FOR PLANNING
S2 ISSUED FOR INFORMATION

PROJECT: Cragside ICT Facility
CLIENT: Cragside ICT Facility
DATE: 17/04/2020
SCALE: AS INDICATED ON DRAWING
DRAWING NO: D10-ARC-83-ZZ-DR-A-401
REVISION: A

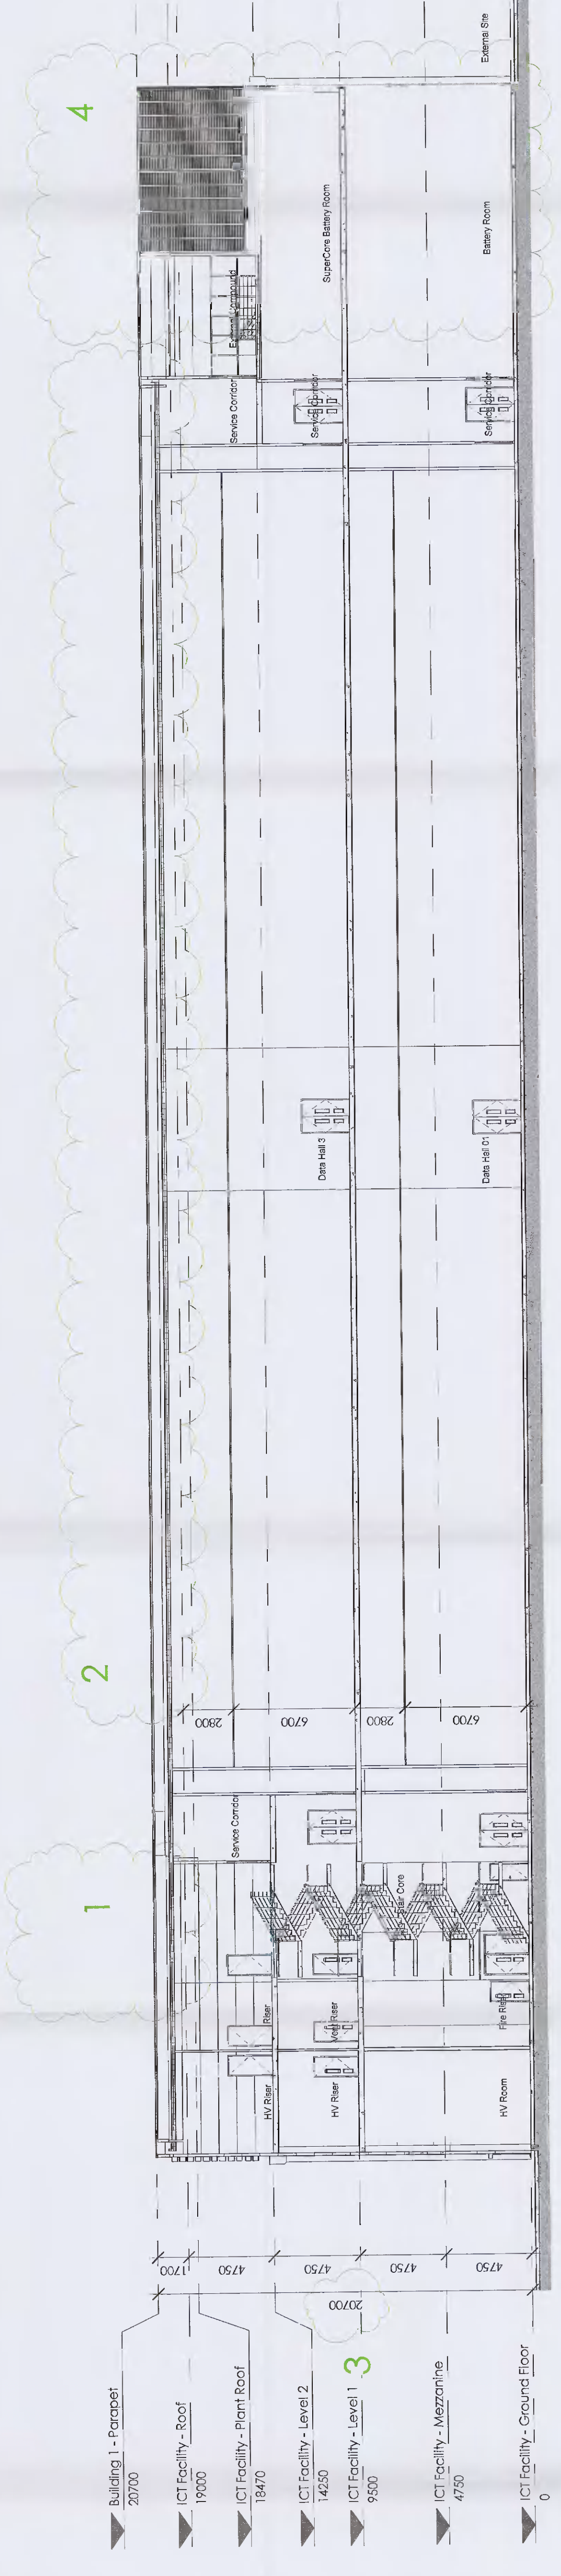
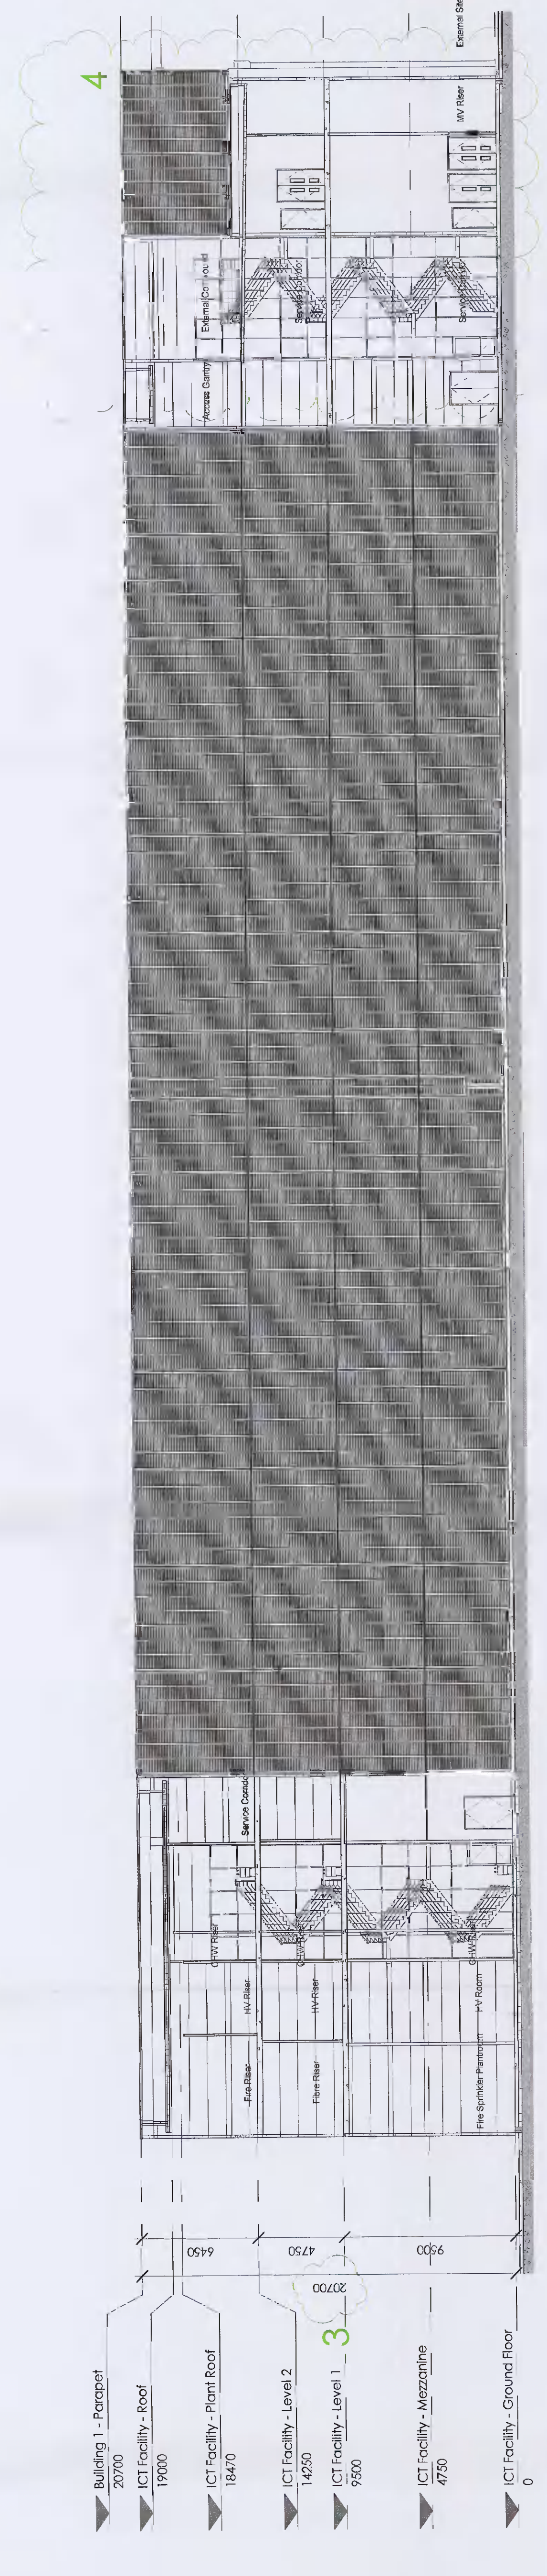
- REVISION: (CT) - CENTRAL EXHAUST FAN REMOVED.
- 2. CENTRAL EXHAUST DUCTS EXTENDING ABOVE PARAPET.
- 3. PARAPET HEIGHT INCREASED FROM 19.5M TO 20.7M.
- 4. ELECTRICAL ROOMS SPLIT EITHER SIDE OF MAIN CT EQUIPMENT ROOMS.
